CITY OF HASTINGS

ADDENDUM NO. 2

Museum Air Handler Replacement

Contract No. CH 2025-36

FIRST FLOOR PLAN - MECHANICAL DEMOLITION

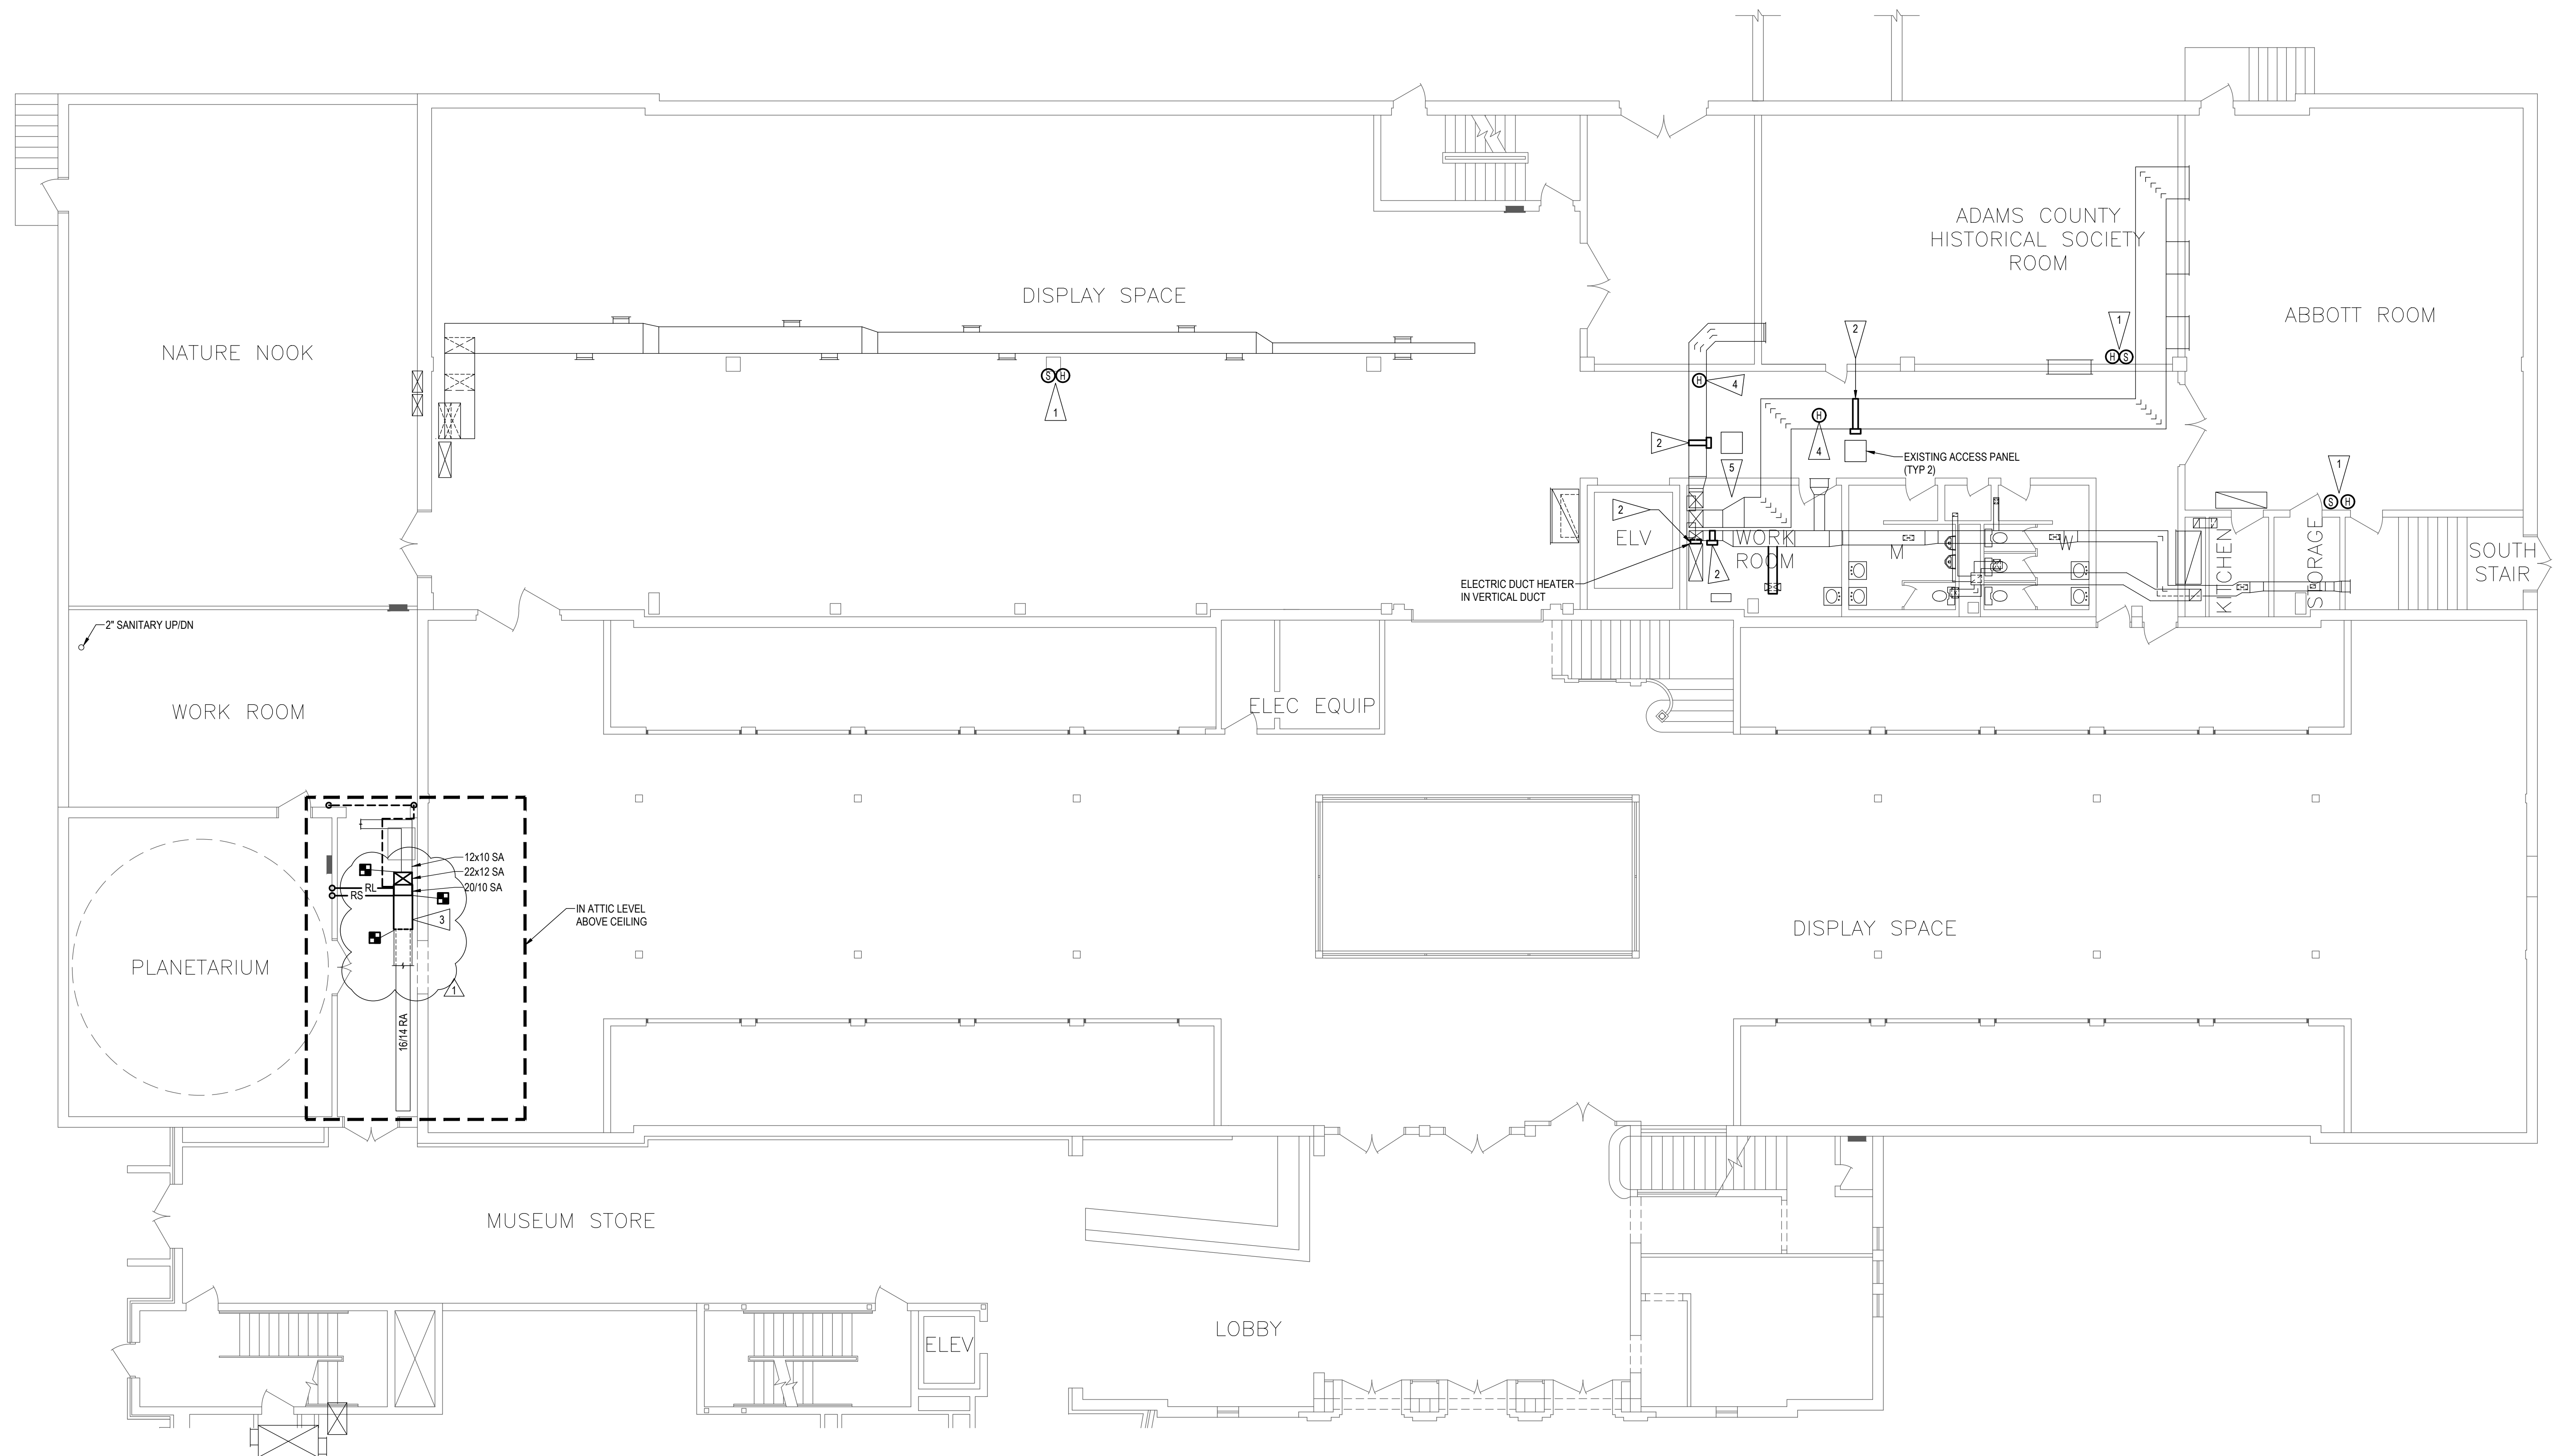
- 1MD1. Sheet M0.2 – First Floor Plan – Mechanical Demolition
 - 1. Modify the existing planetarium supply and return duct removal.
- 1MD2. Sheet M1.2 – First Floor Plan – Mechanical

**BASEMENT FLOOR
PLAN - ELECTRICAL
DEMOLITION**

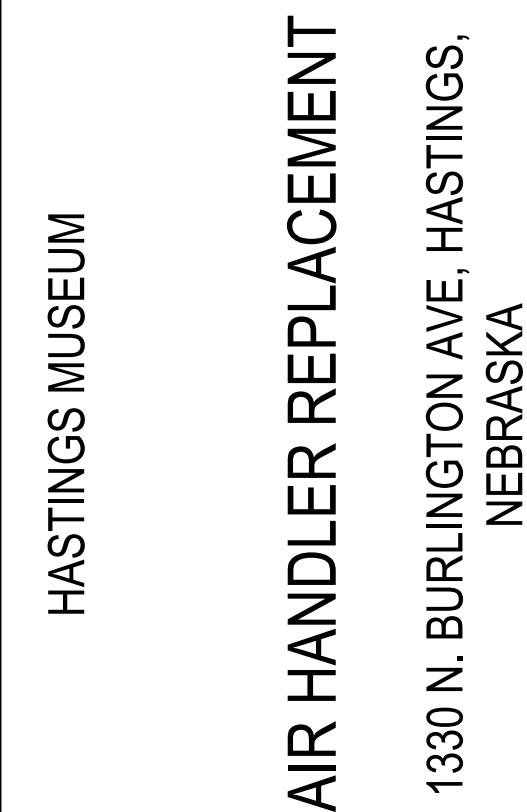
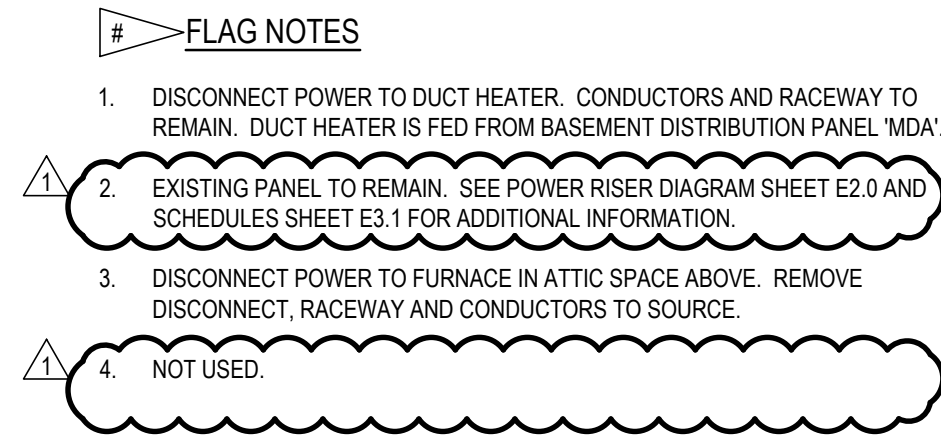
1ED1. Sheet E0.1 – Basement Floor Plan – Electrical Demolition

1. Delete the existing feeder and note from the Existing Switchboard EDP to Panel A.
2. Update Flag Note 1.

BASEMENT FLOOR
PLAN - ELECTRICAL

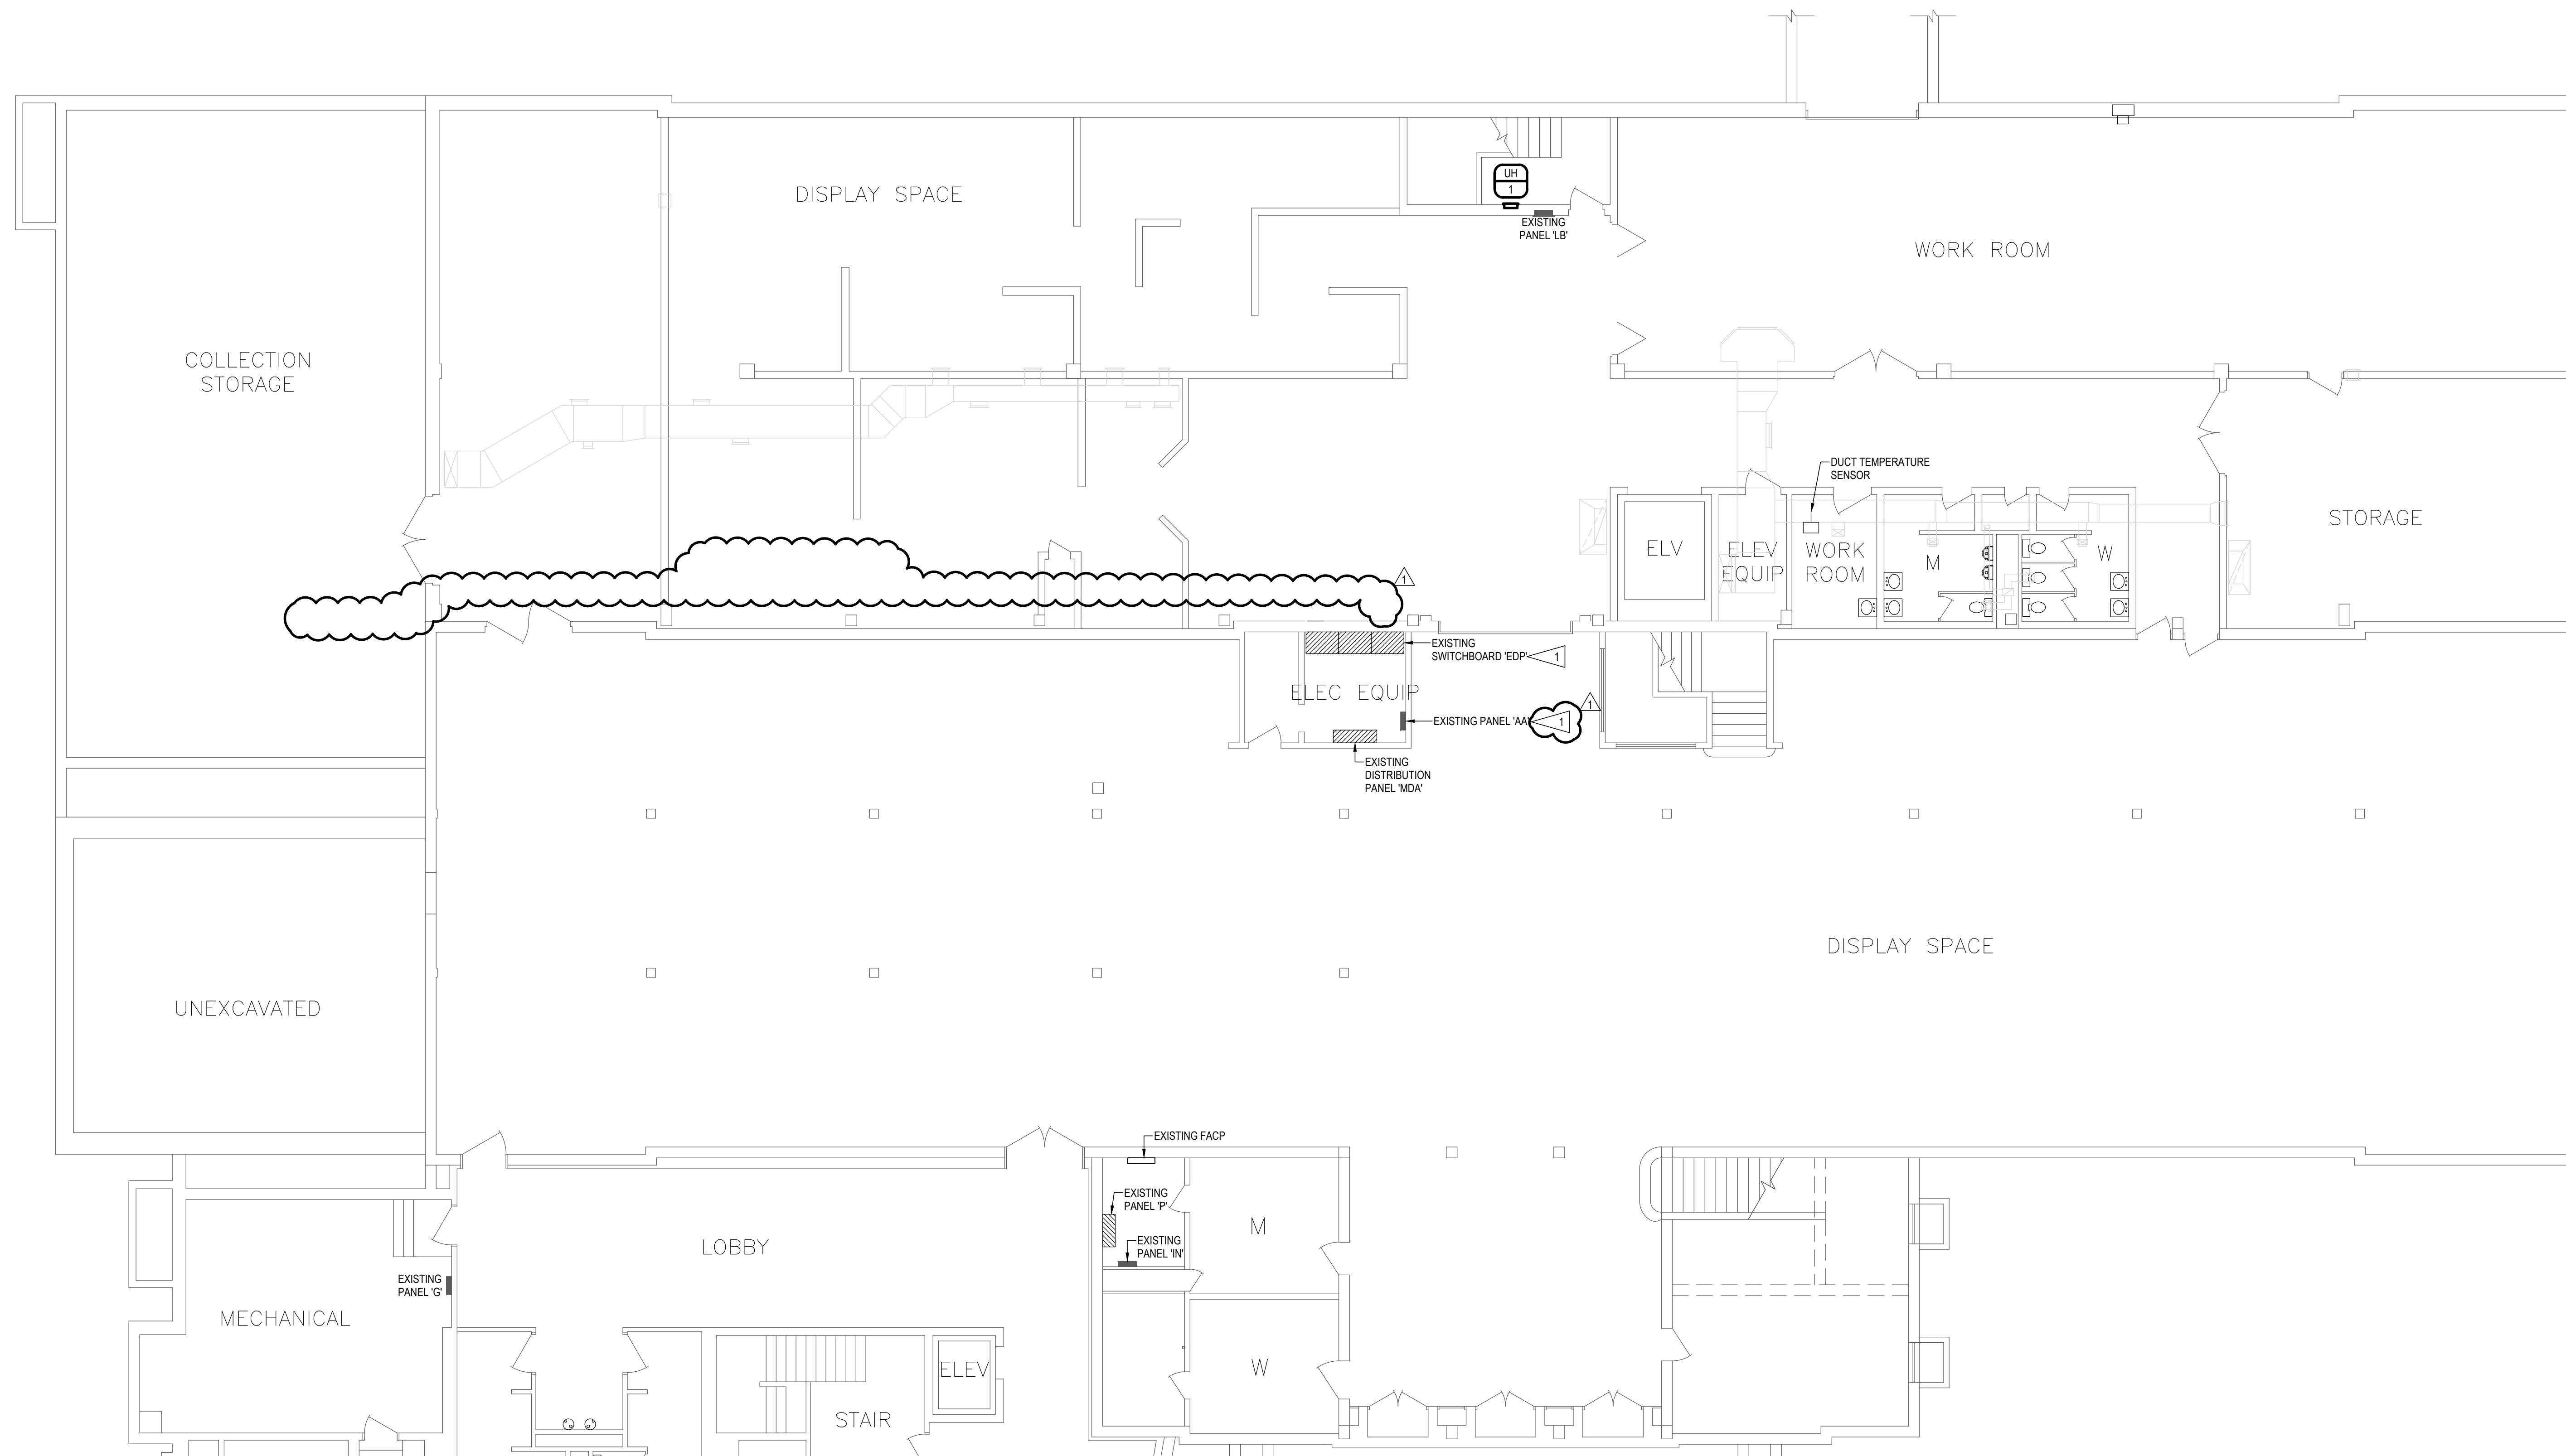
1ED4. Sheet E1.1 – Basement Floor Plan – Electrical

1. Delete existing feeder and note from Existing Switchboard EDP to Panel A.
2. Update Flag Note 1.
